In the Matter of)	
)	Docket No. 50-400-LA
CAROLINA POWER & LIGHT)	
COMPANY)	ASLBP No. 99-762-02-LA
)	
(Shearon Harris Nuclear Power Plant))	
)

AFFIDAVIT OF LAURENCE I. KOPP IN SUPPORT OF THE
NRC STAFF BRIEF AND SUMMARY OF RELEVANT FACTS, DATA
AND ARGUMENTS UPON WHICH THE STAFF PROPOSES TO RELY
AT ORAL ARGUMENT ON TECHNICAL CONTENTION 2

SHEARON HARRIS NUCLEAR POWER PLANT
DOCKET NO: 50-400/LICENSE NO. NPF-63
REQUEST FOR LICENSE AMENDMENT
SPENT FUEL STORAGE

Figure 5.6.1: Burnup Versus Enrichment for PWR Fuel

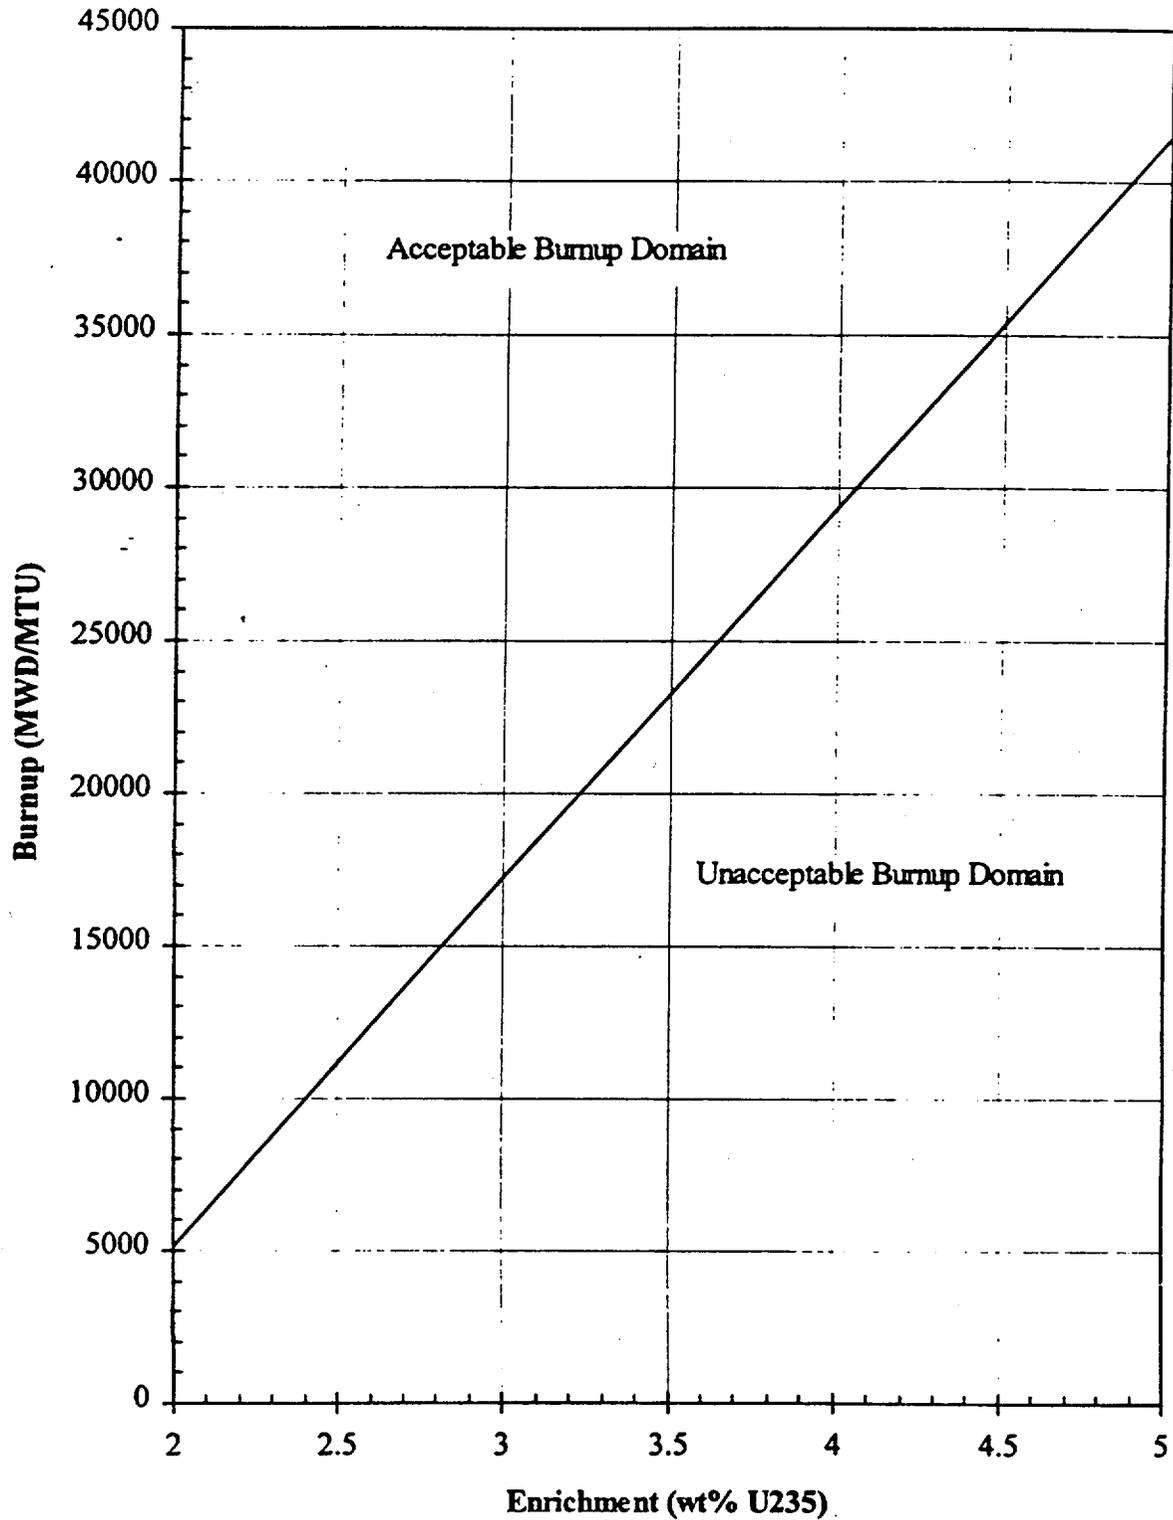
Although the burnup criteria for storage in Pools C or D will be implemented by administrative procedures to ensure verified burnup prior to fuel transfer into these pools, an administrative failure should be assumed and evaluation of a fuel assembly misloading event (i.e., a fresh pressurized-water reactor (PWR) assembly inadvertently placed in a location restricted to a burned assembly as per Technical Specifications (TS) Figure 5.6.1) should be analyzed.

How will the burnup requirements needed to meet TS Figure 5.6.1 be ascertained for fuel assemblies shipped from other PWR plants (Robinson)?

The burnup curve (proposed TS Figure 5.6.1) applies to the Robinson 15 x 15 fuel assembly types identified in Table 4.3.1 of Enclosure 6 to CP&L's license amendment request, dated 12/23/98.
